**STATE OF HAWAII
DEPARTMENT OF TRANSPORTATION
HIGHWAYS**

**ADDENDUM NO. 2
FOR
TRAFFIC SIGNAL MODERNIZATION, OAHU, PHASE 2A
DISTRICT OF HONOLULU
ISLAND OF OAHU
FEDERAL-AID PROJECT NO. STP-0300(214)**

NOVEMBER 8, 2024

PROFILE - DUCT LINE 11
Scales: Horiz. 1" = 5'
Vert. 1" = 5'

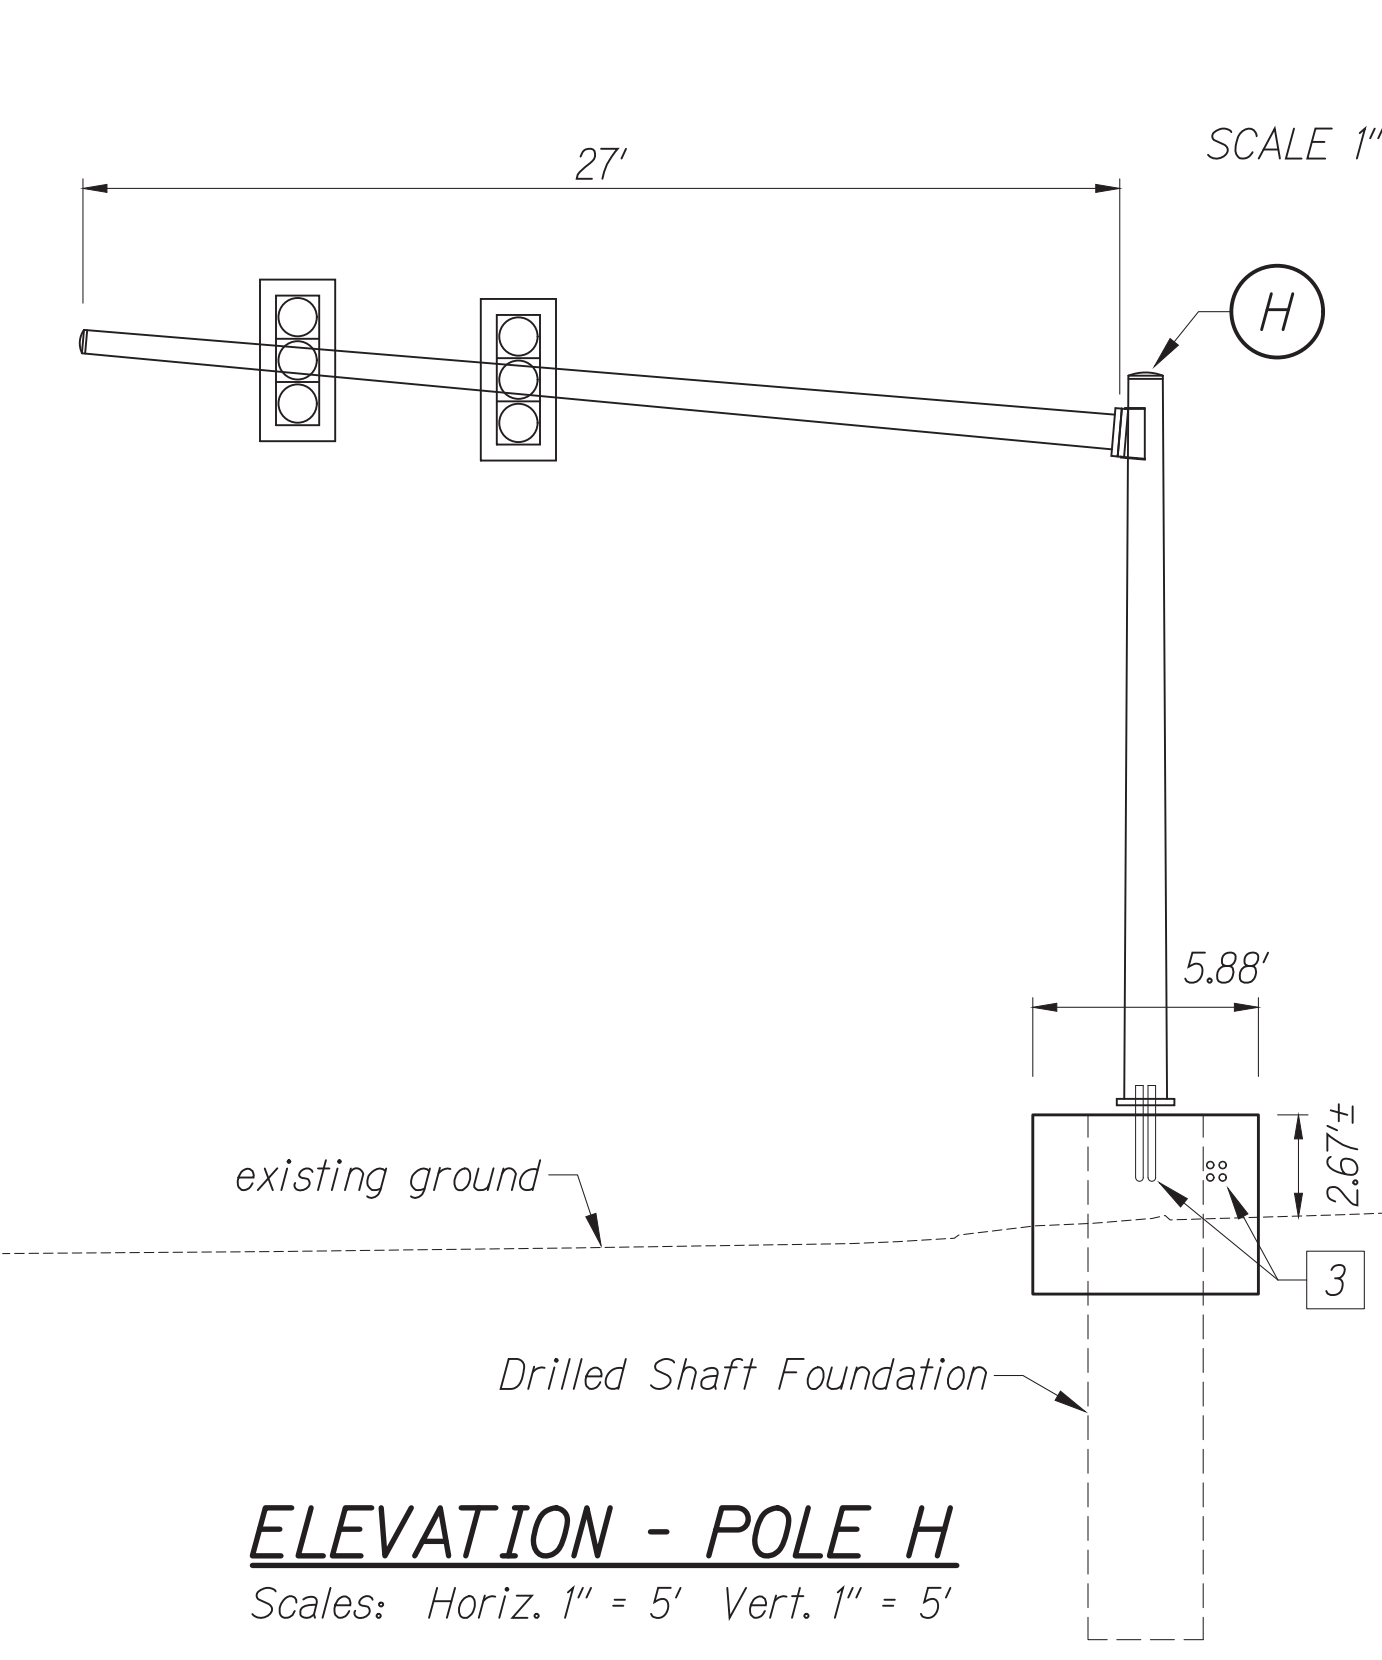
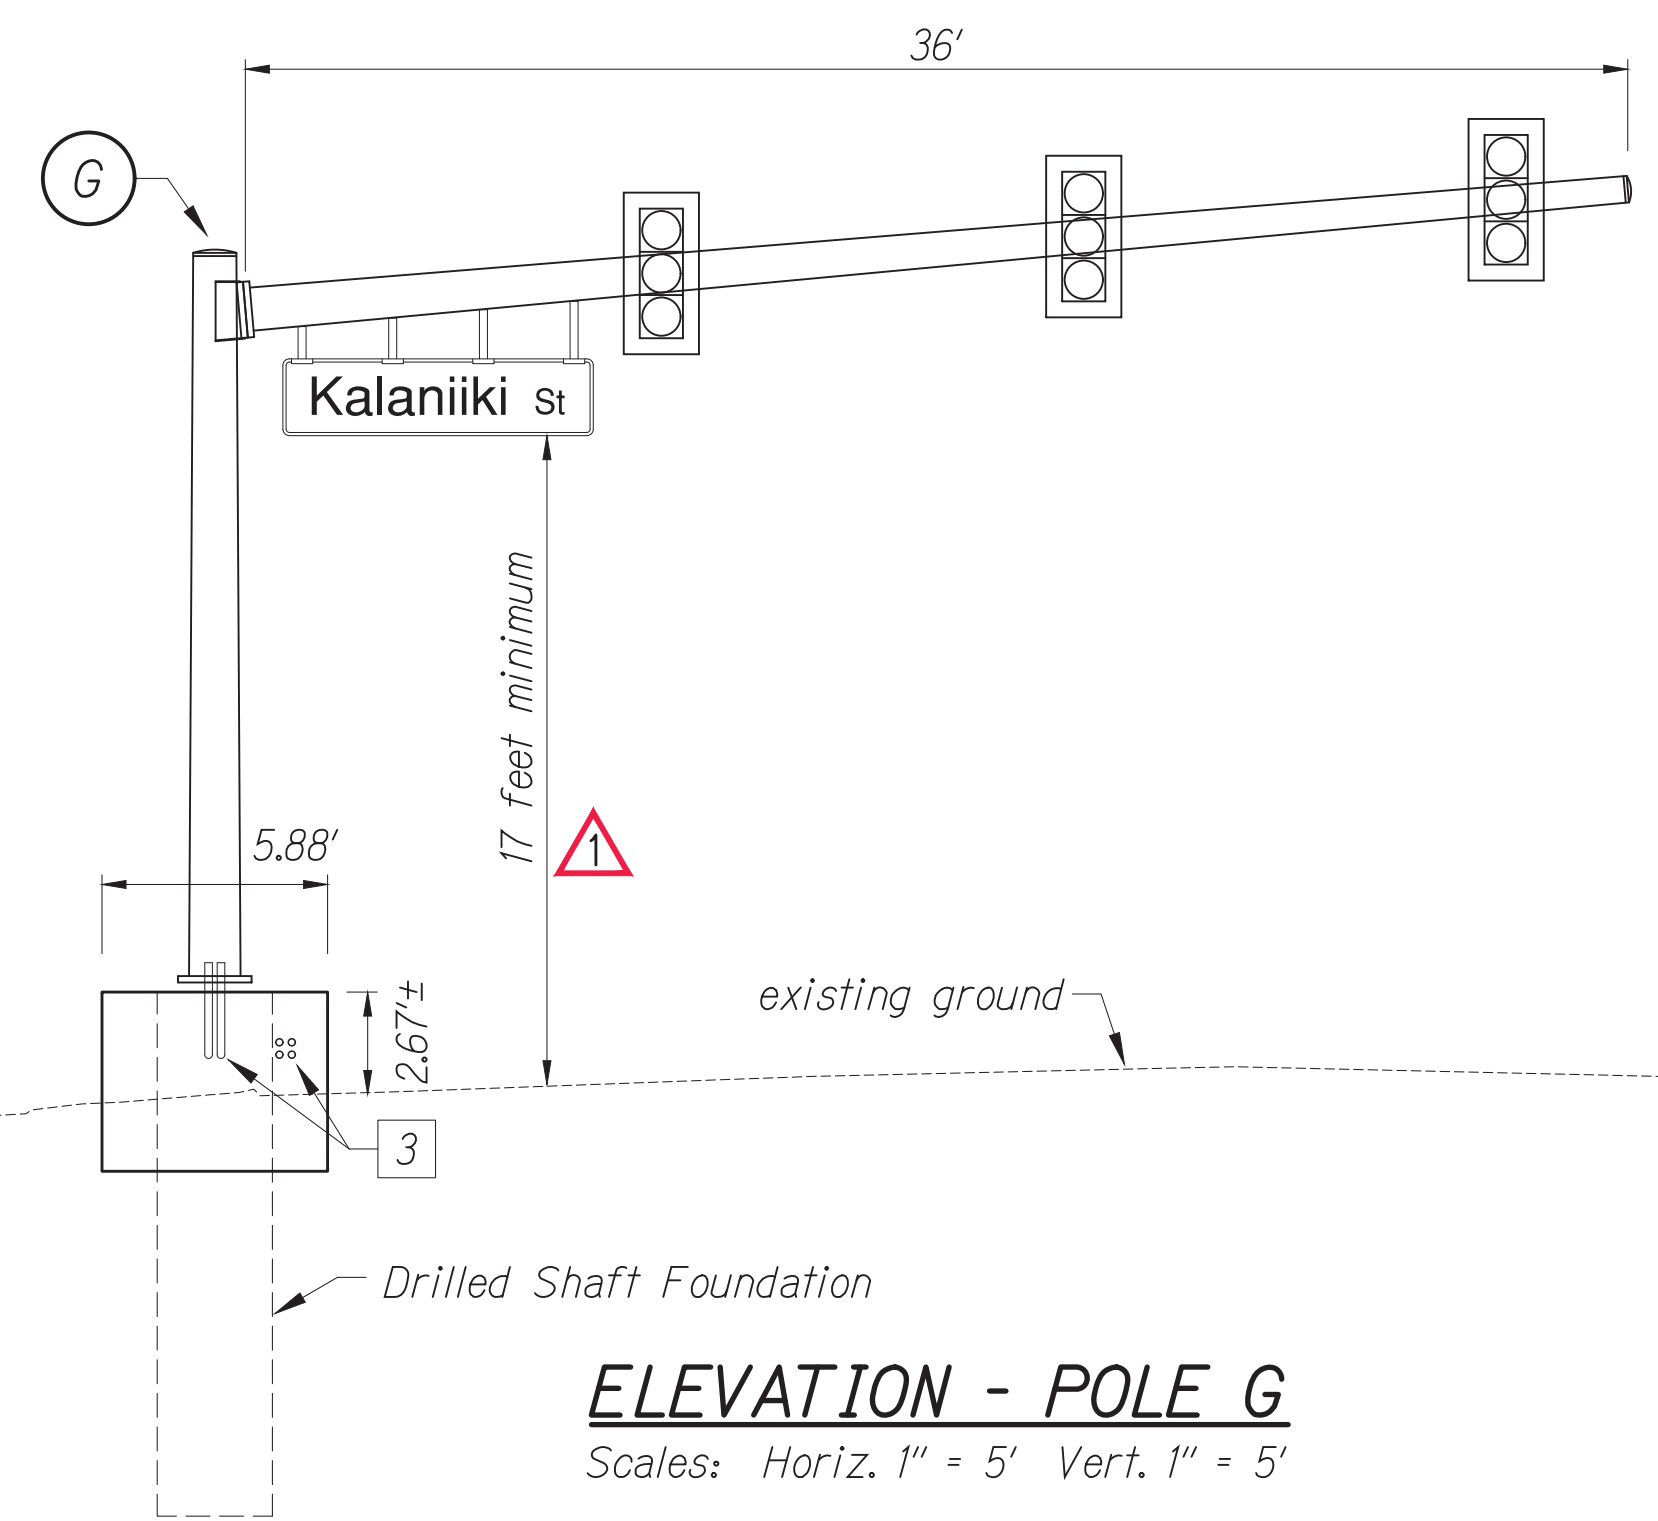
REVISION	DATE
Revised call out to 17-foot minimum clearance (in lieu of 15-foot) from bottom of street name sign on mast arm to top of pavement of travel lane.	11/8/24

FED. ROAD DIST. NO.	STATE	PROJ. NO.	FISCAL YEAR	SHEET NO.	TOTAL SHEETS
HAWAII	HAWAII	STP-0300(214)	2024	ADD.106	149

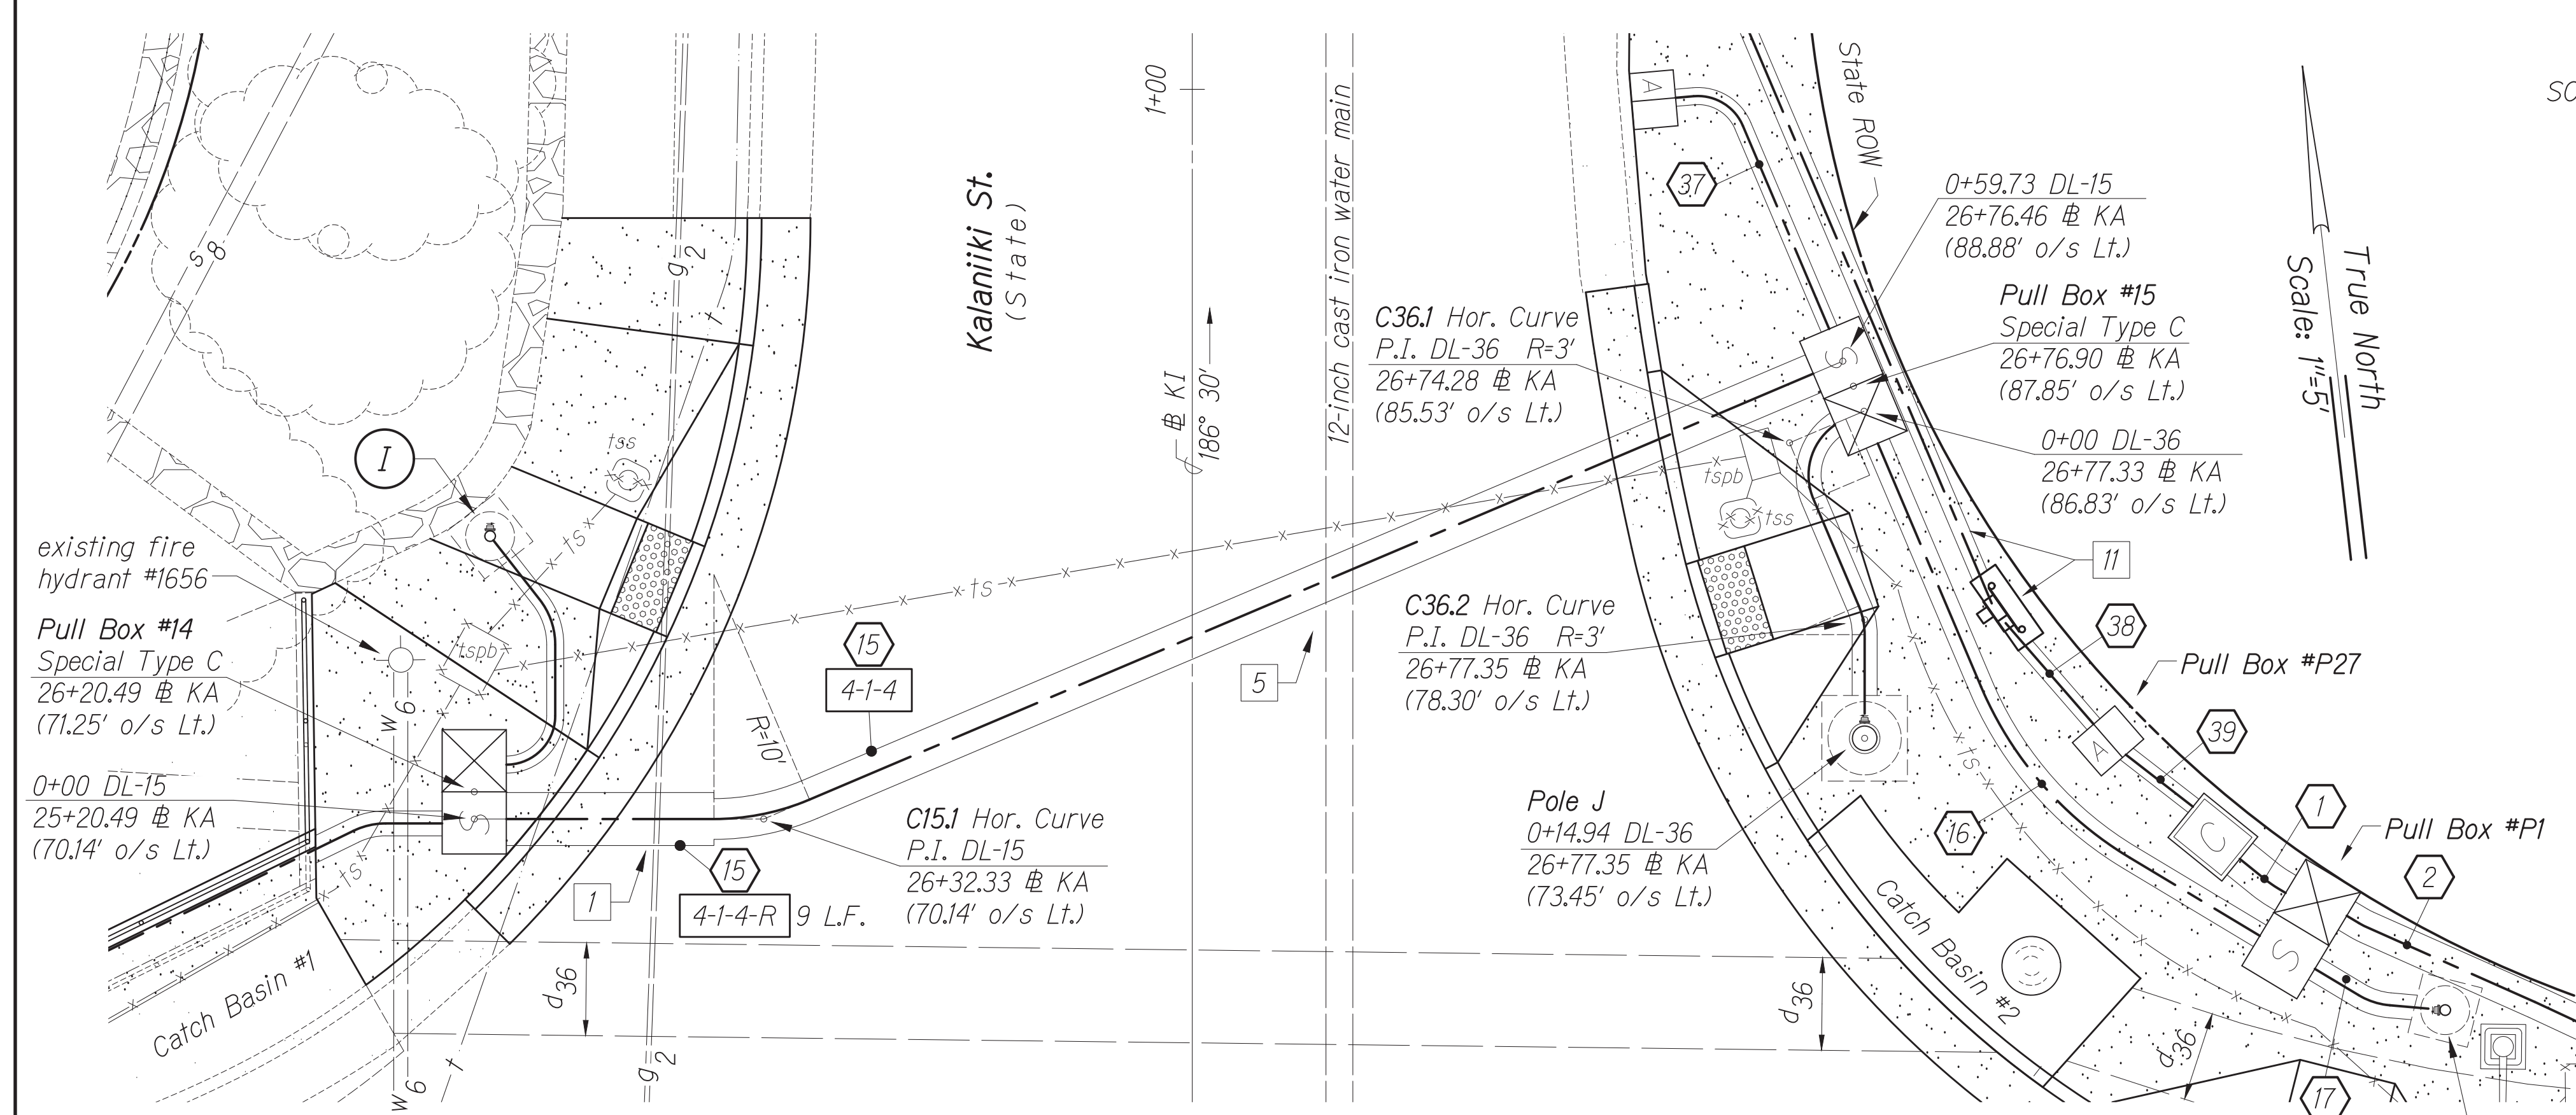
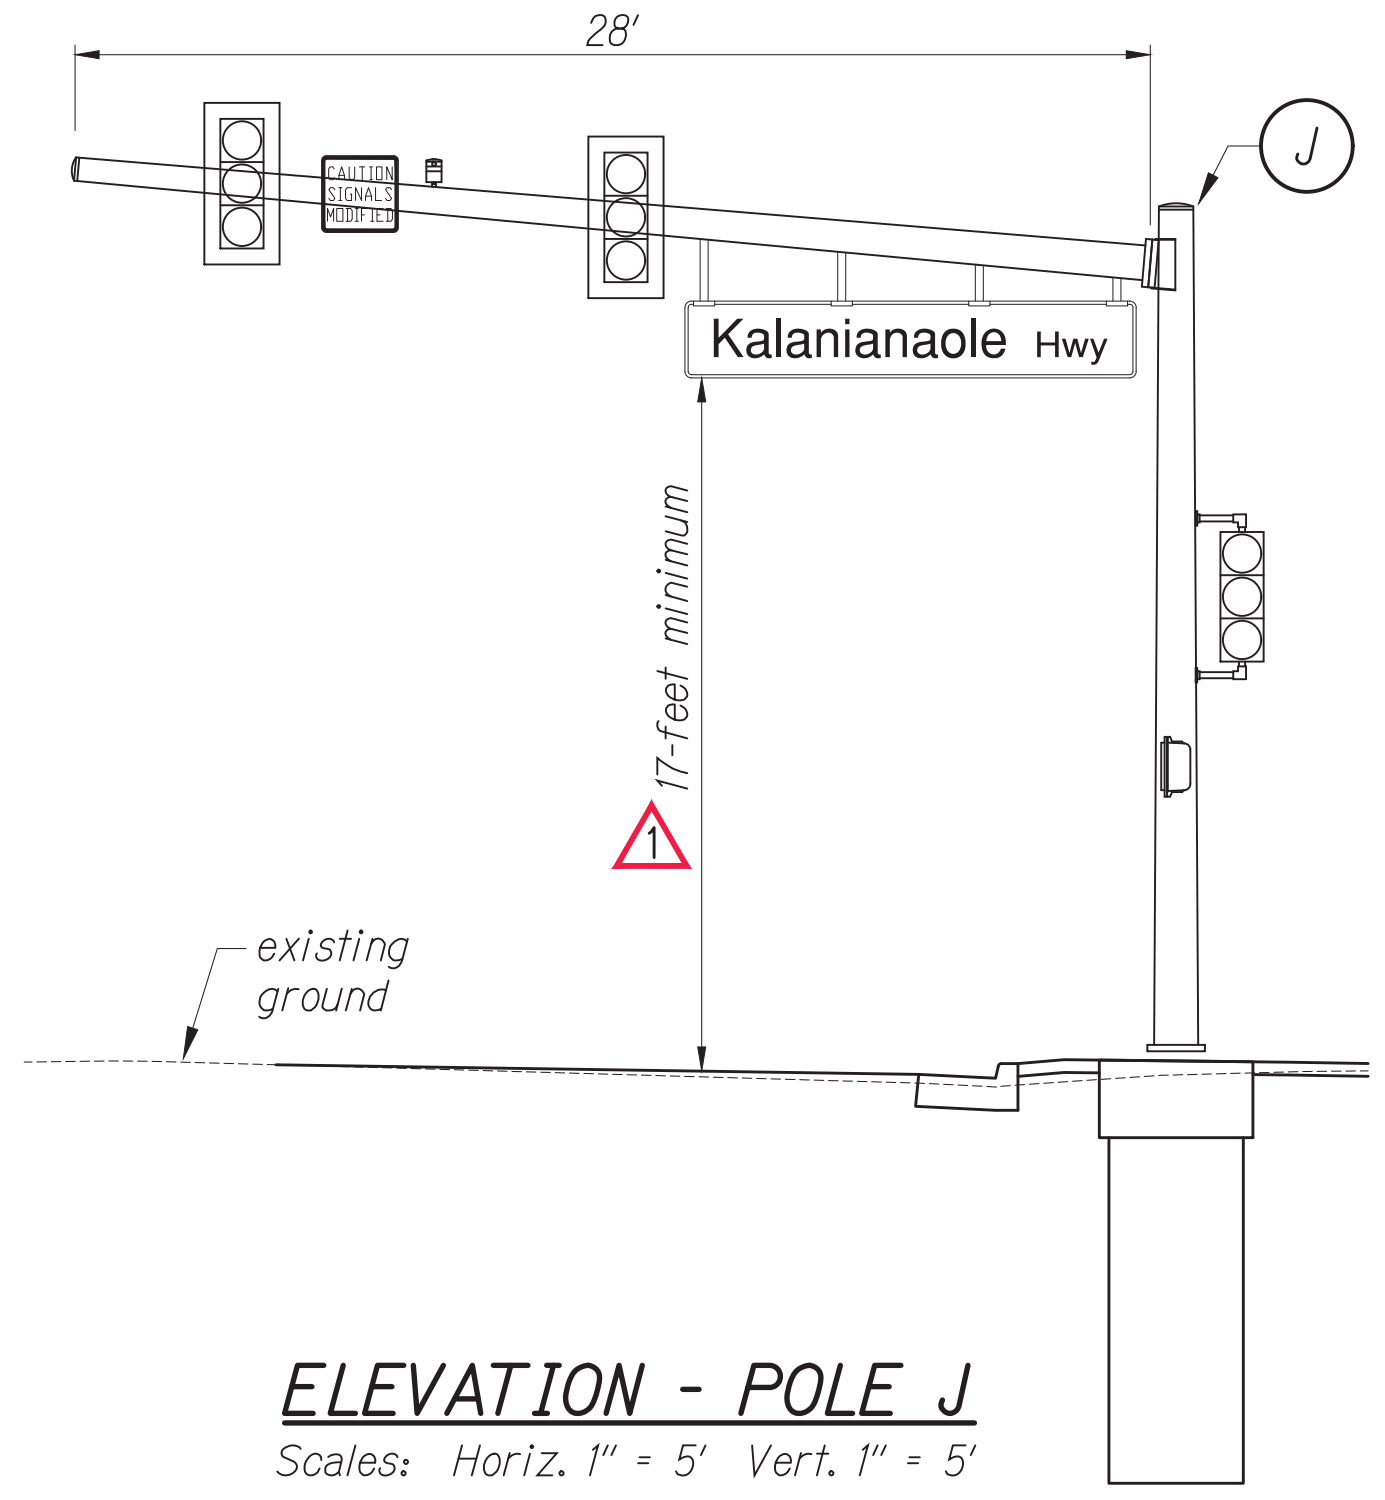
Revised call out to 17-foot minimum clearance (in lieu of 15-foot) from bottom of street name sign on mast arm to top of pavement of travel lane.
